**From:** Christopher.Rog@ghd.com  
**Sent:** Tuesday, March 27, 2018 10:18 AM  
**To:** Stoltz, Carrie R - DNR  
**Subject:** RE: Kabel / Lindey Additional Borings  
**Attachments:** 11139422Kost-1-Results and Closure Request.pdf; proposed Kabel Lindey Borings.pdf

**Subject:** Kabel / Lindey Additional Borings

FORMER LINDEY CLEANERS  
34 SOUTH STEVENS STREET  
RHINELANDER, WI

DATE: MAY 2015	DRAWN BY: KAP
SCALE: 1"=20'	APPROVED BY: CJR
<b>FIGURE 3</b>

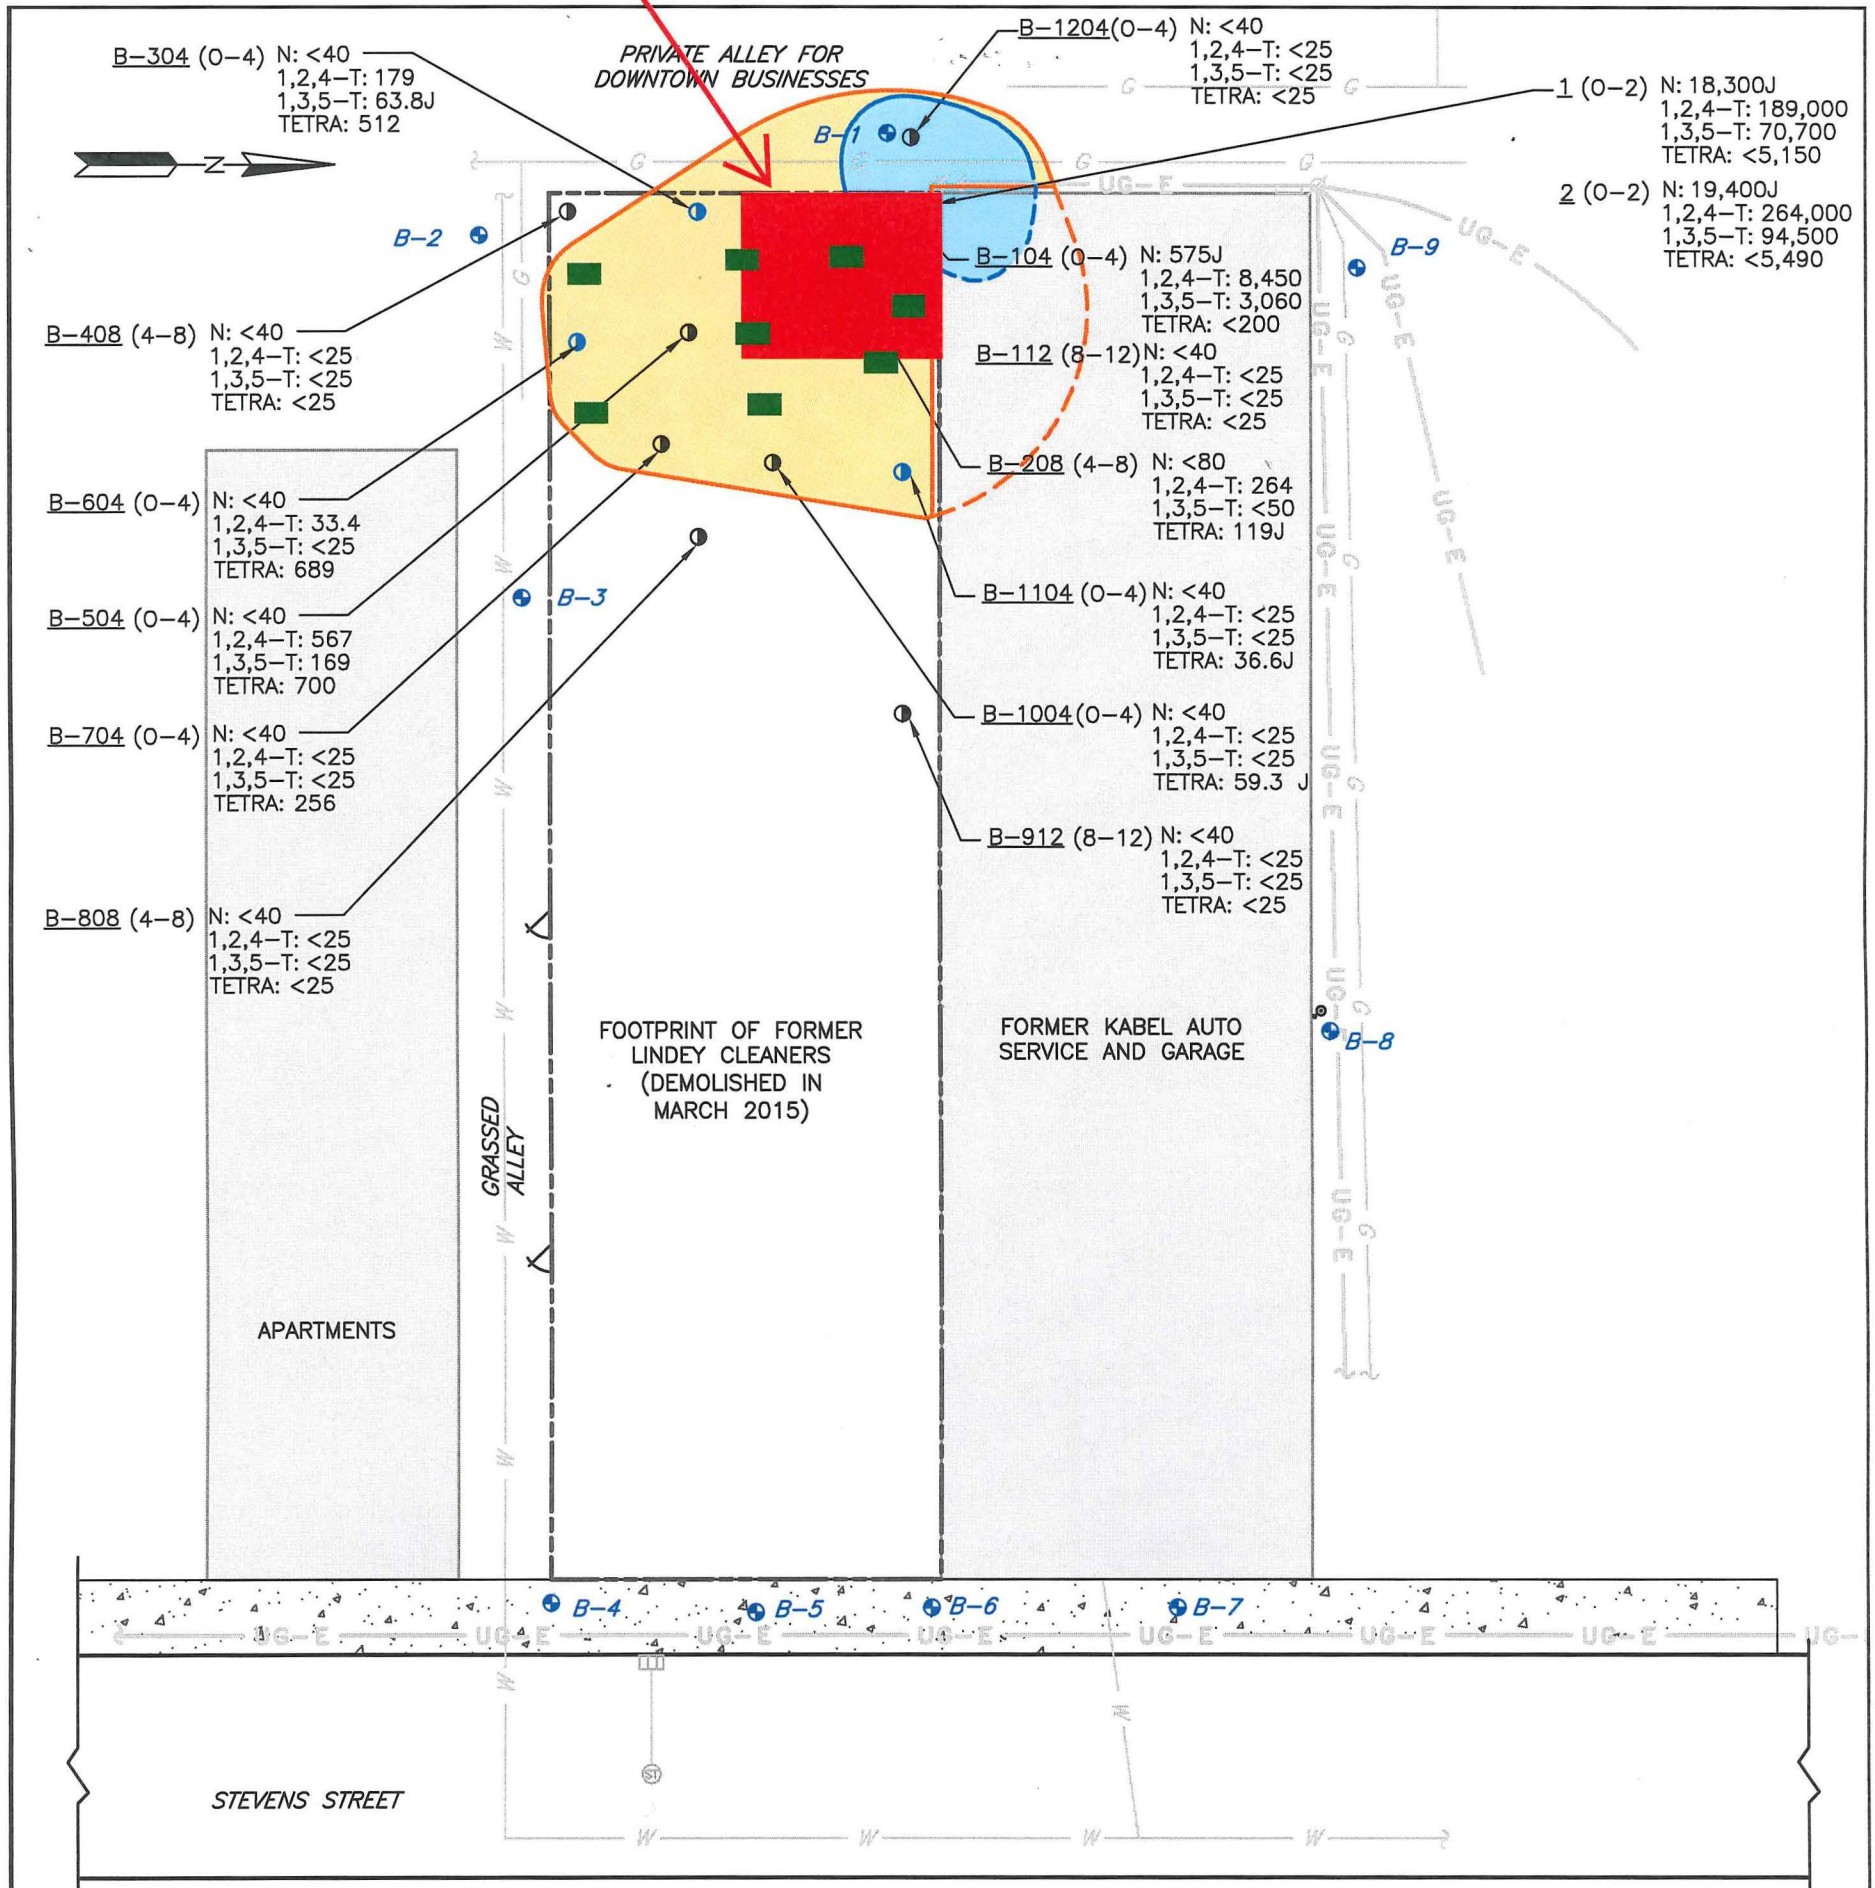
**Figure 3:**

Where is the location of boring 2? At the southwest corner of the building, by the tip of the north arrow.

What does the large red square mean? That was the proposed dig area, if we were to dig the direct contact soils. See comment below on that.

I am assuming the green squares are proposed soil borings that are not marked and are not in the "key. How deep will be borings go? What is the sampling plan? From an email from Ryan:

Why are you planning to excavate to 10' for D.C, soils? Where is the proposed excavation-the figure is not clear. The red square was the initially proposed dig, which I moved out of the way to show more borings, but

Where is the location of boring 2?

What does the large red square mean?

I am assuming the green squares are proposed soil borings that are not marked and are not in the "key. How deep will be borings go? What is the sampling plan?

Why are you planning to excavate to 10' for D.C, soils? Where is the proposed excavation-the figure is not clear

The draft budget includes twelve borings to 12-feet and only includes soil sampling. I'd propose to collect three soil samples per boring and only analyze the deep samples if the shallower samples came back above criteria.  
Ryan

it's going to be either more investigation (the drilling) or skip the drilling and do a dig. The City will make that call shortly on which way we proceed. In the attached I moved the red square back to the proposed dig area. Sorry. The blue direct contact soils do not extend outside the footprint of the building as this map implies and needs to be corrected (and will be)
